**BEFORE THE BOARD OF PATENT APPEALS
AND INTERFERENCES**

Application Number: 09/682,142
Filing Date: July 26, 2001
Appellant(s): SIVAVEC ET AL.

EXAMINER'S ANSWER

Figure 12. PRB configuration, Mountainview, California.

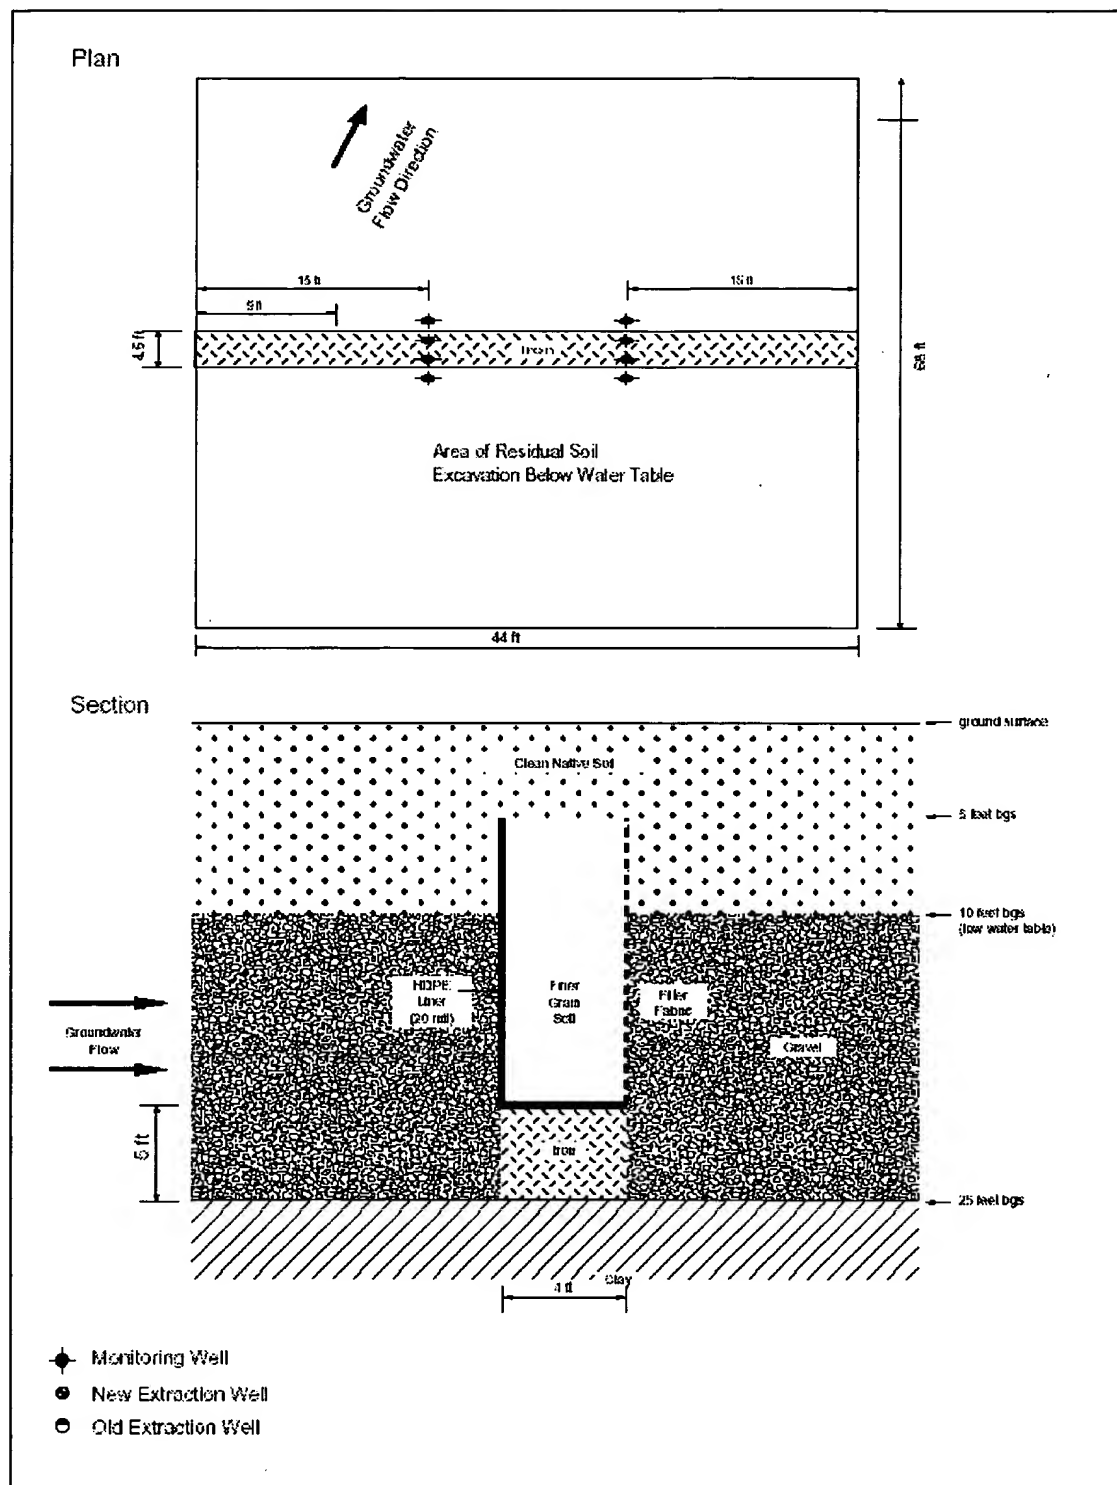
The Figure 17 referred to in the EPA Paper above is the same as Figure E-3, page E-6 of The PRB Papers discussed above. Fig 12, page 42 of the EPA Paper shows the PRB configuration of Mountainview, California:

This Figure, showing the layout at Mountainview California, supports examiner's assertion that locating monitoring wells upgradient, downgradient, and within the PRB as disclosed by appellants was known to one of ordinary skill in the art, as the PRB project in Mountainview California was one of the 39 sites disclosed in The PRB Papers and was also disclosed in the EPA Paper published in 9/1998 which one appellant co-authored.
